Form 3160-3 (June 2015)			OMB N	APPROVED o. 1004-0137 anuary 31, 2018	
UNITED STATES		inuary 51, 2018			
DEPARTMENT OF THE I BUREAU OF LAND MAN			5. Lease Serial No. NMNM97127		
APPLICATION FOR PERMIT TO D			6. If Indian, Allotee	or Tribe Name	
1a. Type of work: Image: Constraint of the second seco	EENTER		7. If Unit or CA Ag	reement, Name and No.	
1b. Type of Well: Oil Well Gas Well O	ther		8. Lease Name and	Well No	
1c. Type of Completion: Hydraulic Fracturing 🖌 Si	Multiple Zone	HONEY BUN 6 FE			
			725H

2. Name of Operator EOG RESOURCES INCORPORATED			9. API well No. 30	0-015-54244	
3a. Address 1111 BAGBY SKY LOBBY 2, HOUSTON, TX 77002	3b. Phone (713) 651	No. (include area code)	10. Field and Pool, WC-025 G-08 S24	or Exploratory 3217P/WOLFCAMP (G

WELL LOCATION AND ACREAGE DEDICATION PLAT

880' FNL 1598' FEL Section 6 T-26-S, R-27-E Proposed Wellbore Design B KB: 3,317' GL: 3,292'

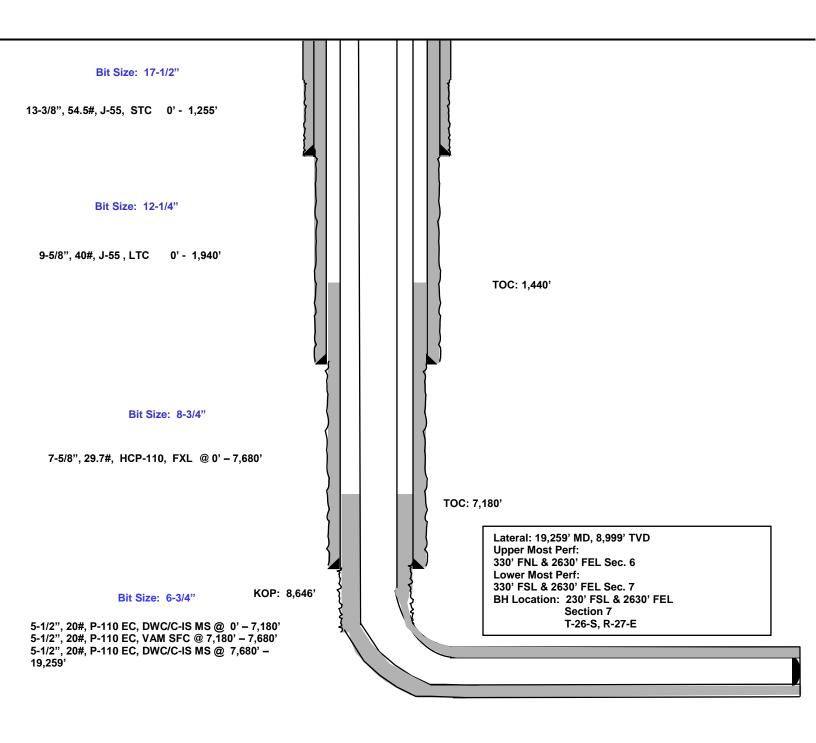
Operator is only approved for Design A. Design B is not to be utilized. If Design B is needed or any other change, please submit a NOI sundry to make the changes.
